**Re: Response Letter to Auckland Council Comments
538 Karangahape Road, Auckland
RWDI Reference No. 2405832**

This letter is in response to the RFI from Auckland Council (received by RWDI on 9 September 2024), seeking additional information on the Computational Fluid Dynamics (CFD) study undertaken for the proposed 538 Karangahape Road development located in Auckland. (Ref: 20240729 RWDI 2405832 REP WindDesignReview 538KarangahapeRoad).

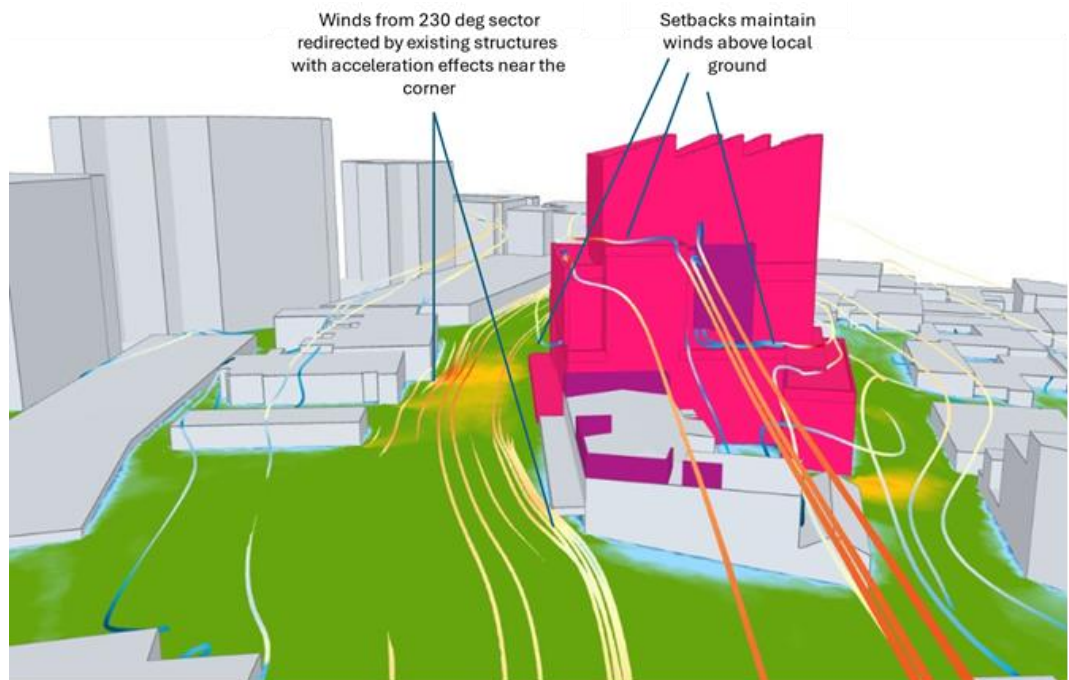
Council Comment 2

Image 6a shows Category C-D and E, circled below. These areas appear to be on the footpath, and Category D and E do not include footpaths, which if located on the footpath would represent an infringement of H8.6.28.(1)(a). Please confirm where exactly the C-D and E categories shown below are located (i.e. on footpaths or in carriageways). It may be useful to have an aerial photo overlay and confirmation from the wind specialists.

RWDI Response to Comment 2

Along Karangahape Road, the results are influenced by the modelling simplifications. The neighbouring site was modelled without the inclusion of the awning along the footpath, and the building massing was simplified. As a result, it is anticipated that wind conditions would be calmer than indicated in from the simulations. The area to the north of the building is therefore likely to be lower than that shown.

For the on-site wind conditions along Abbey Street, please refer to the overlay below, which shows the expected wind speeds (in m/s) along the footpath. Notably, most areas where Category D conditions are expected align with the car park access to the neighbouring property. Given that the driveway area is primarily used for ‘business walking’ (i.e., Category D), where people are likely moving from point A to point B without lingering, the current wind conditions are consistent with this type of usage and compliant with the relevant standard.
